Design, Build and Finance (DBF) for Zumalai to Natarbora Highway Project

Tender/040/MPRM-2025

Clarification No. 4

26 June 2025
Clarification No. 3

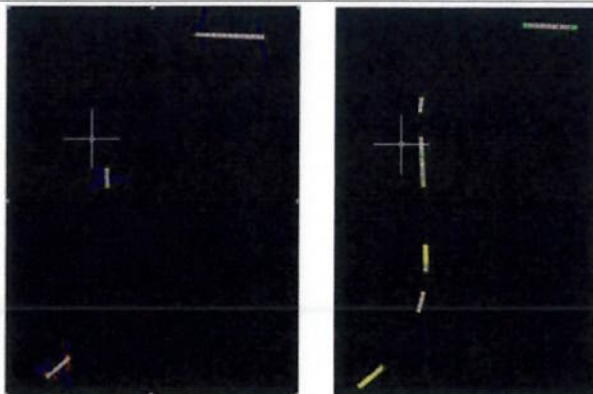
3.	<p>Road Profile. There are two versions of profiles for the same sections in VOLUME 6 - PART II - EMPLOYER'S REQUIREMENTS (DRAWINGS) Native File. One example of those discrepancies for the same sections is shown as below, regarding the discrepancies in profiles and structural arrangements.</p> 	<p>The drawings presented in VOLUME 6: PART II - EMPLOYER'S REQUIREMENTS (DRAWINGS) in PDF signed version shall prevail.</p>
4.	<p>Structural Arrangements Road Profile. There are two versions of profiles for the same sections in VOLUME 6 - PART II - EMPLOYER'S REQUIREMENTS (DRAWINGS). One example of those discrepancies for the same sections is shown as below, regarding the discrepancies in structural arrangements.</p>	<p>The drawings presented in VOLUME 6: PART II - EMPLOYER'S REQUIREMENTS (DRAWINGS) in PDF signed version shall prevail.</p>
